**Subject:** MHI's Responses to US-APWR DCD RAI No. 659-5133 Revision 2 (SRP 03.07.01)

Response to Request for Additional Information No. 659-5133,  
Revision 2

**RAI NO.:** NO. 659-5133 REVISION 2  
**SRP SECTION:** 03.07.01 – Seismic Design Parameters  
**APPLICATION SECTION:** 3.7.1  
**DATE OF RAI ISSUE:** 11/15/10

**QUESTION NO. RAI 03.07.01-17:**

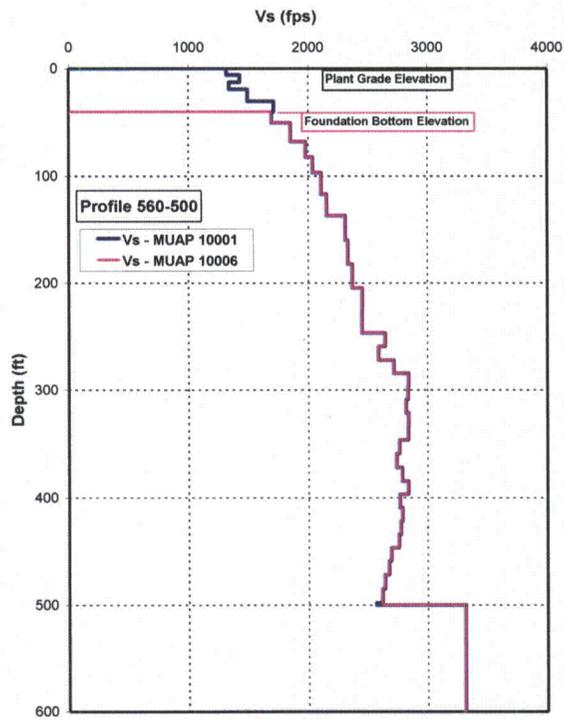
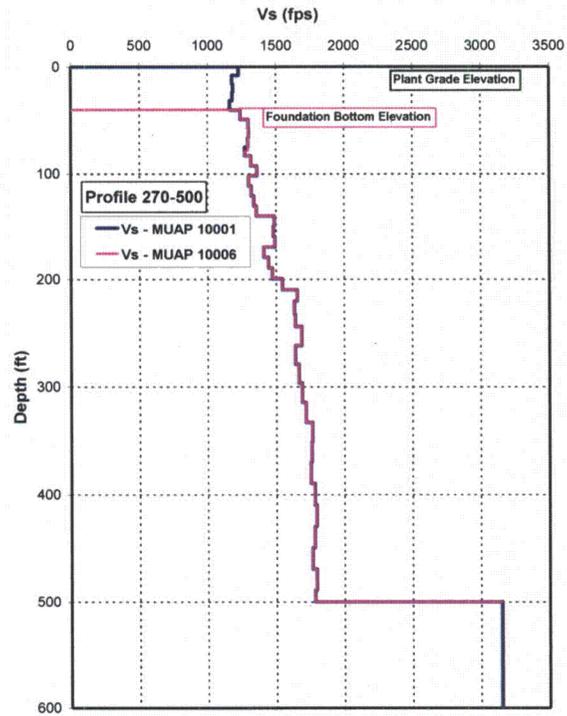
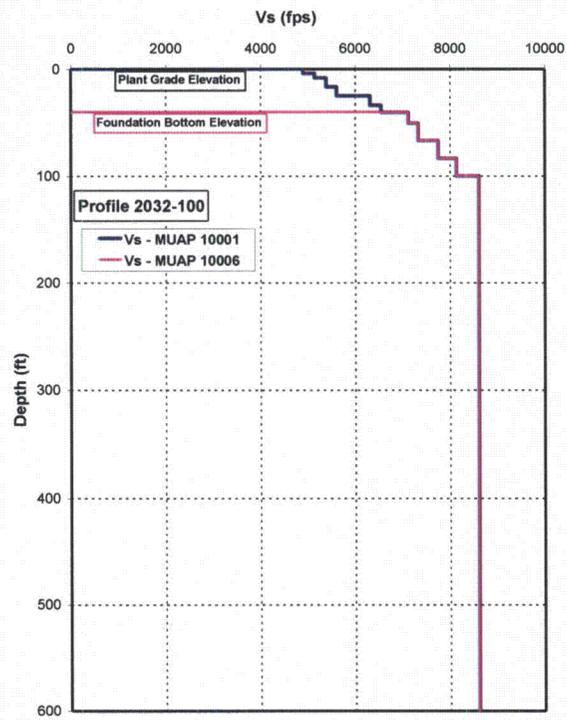
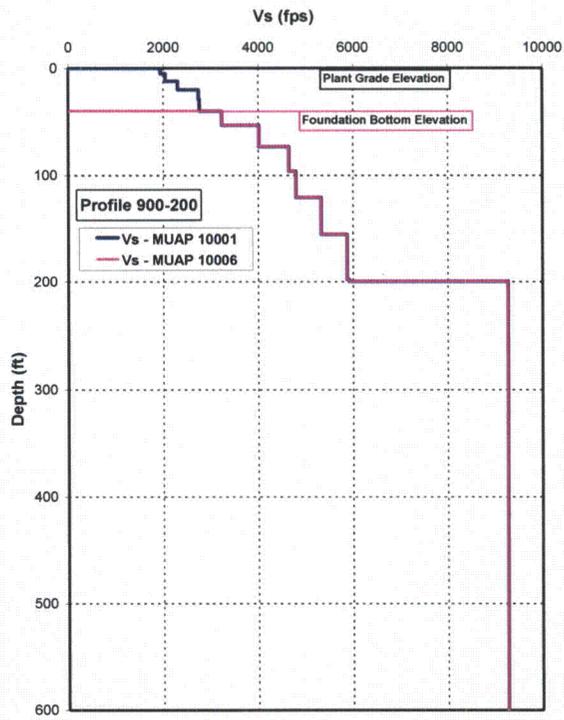
Section 3.2 of MHI's Topical Report, MUAP-10006 (R0), addresses site conditions and states that Tables 3-3A through 3-3H present the input material properties of the subgrade. However, the basis for the values in these tables is not discussed. In order to conduct a technical evaluation of the supporting media used for the seismic analysis, the staff requests that the applicant provide the following information:

1. The origin of the information in the tables
2. A description of how and to what extent the information does or does not relate to the data shown in Tables 5.2-3 through 5.2-11 of MUAP-10001 (R1)
3. A statement as to whether the properties shown are low-strain or strain-iterated properties
4. If the properties are strain-iterated properties, a description of which time histories (i.e. horizontal H1, horizontal H2, vertical, or some combination) were used to generate the properties
5. A description of how the compressional wave speeds and damping used in the vertical seismic analysis were developed.

1. MHI Technical Report MUAP-10001 Section 5.2 is the origin of the information contained in Technical Report MUAP-10006 Tables 3-3A through 3-3H. Please note that the strain compatible properties for generic profiles 270 and 560 listed in Tables 5.2-3 through 5.2-8 of MUAP-10001(R1) have been revised in Revision 2 of the report to show the updated results of the site response analyses.
2. The median strain-compatible soil properties listed in Tables 5.2-3 through 5.2-11 and shown in Figures 5.2-6 through 5.2-14 of the updated revision of MUAP-10001(R2) Section 5.2 are used as input for the site-independent soil-structure interaction (SSI)

analyses of US-APWR standard plant Category I buildings documented in MUAP-10006(R0). The site independent SSI analyses consider the foundations of the Category I buildings to be supported on the surface of the subgrade that is located at depth approximately 40 ft below the surface of the finished grade of the plant. Since the top 40 ft of the soil are excavated, the eight generic subgrade profiles used for the site independent SSI analyses of surface mounted foundations are obtained by removing the top 40 ft of soil from the generic profiles with median strain-compatible properties developed in Technical Report MUAP-10001. The layering of the profiles are adjusted in order to ensure that the ACS SASSI models are capable of transmitting seismic waves with frequencies equal to or lower than the cut off frequency of SSI analyses. The figures below show comparison of the profiles of the median shear wave velocities obtained from the site response analyses in MUAP-10001 and the profiles of the shear velocities used as input for the SSI analyses presented in MUAP-10006. Please note that in response to RAI 625-4924, it has been explained that one soil profile, the "270-100" profile and its associated Table 5.2-3 and Figure 5.2-8, is to be deleted from suite of profiles considered in the standard design.

3. Refer to MUAP-10001 Section 4.2.2. The properties are equivalent to strain-iterated properties. The approach for the US-APWR CSDRS strain compatible properties is that the properties are developed in a fully probabilistic manner, in which each base-case profile is randomized in velocity as well as nonlinear dynamic material properties. Thirty realizations were generated for each profile category and depth to hard or soft rock. Random vibration theory (RVT) equivalent-linear site response analyses were then performed on each random profile for horizontal motions while for vertical motions, linear analyses were used by assuming that the soil compressional velocities are not strain dependent. Section 5.2.1 of MUAP-10001 provides more information regarding the approach used for site response analyses for vertical motions and how the results of these analyses relate to the vertical CSDRS design spectrum which is based on the RG 1.60 V/H ratio. For the horizontal component site response analyses, modulus reduction and hysteretic damping curves from EPRI TR-102293 are used. The curves are appropriate for generic soils comprised of gravels, sands, and low PI clays. For the soft and firm rock profiles (560m/sec and 900m/sec), an unpublished suite of curves appropriate for soft and firm rock conditions were used. The rock curves were developed during the EPRI project (refer to TR-102293) assuming soft and firm rock exhibits a nonlinear dynamic material behavior similar to gravels. The rock curves were not included in TR-102293 as the final suite of amplification factors was based on soil profiles intended to capture the behavior of soils ranging from gravels to low plasticity sandy clays at CENA nuclear power plants.
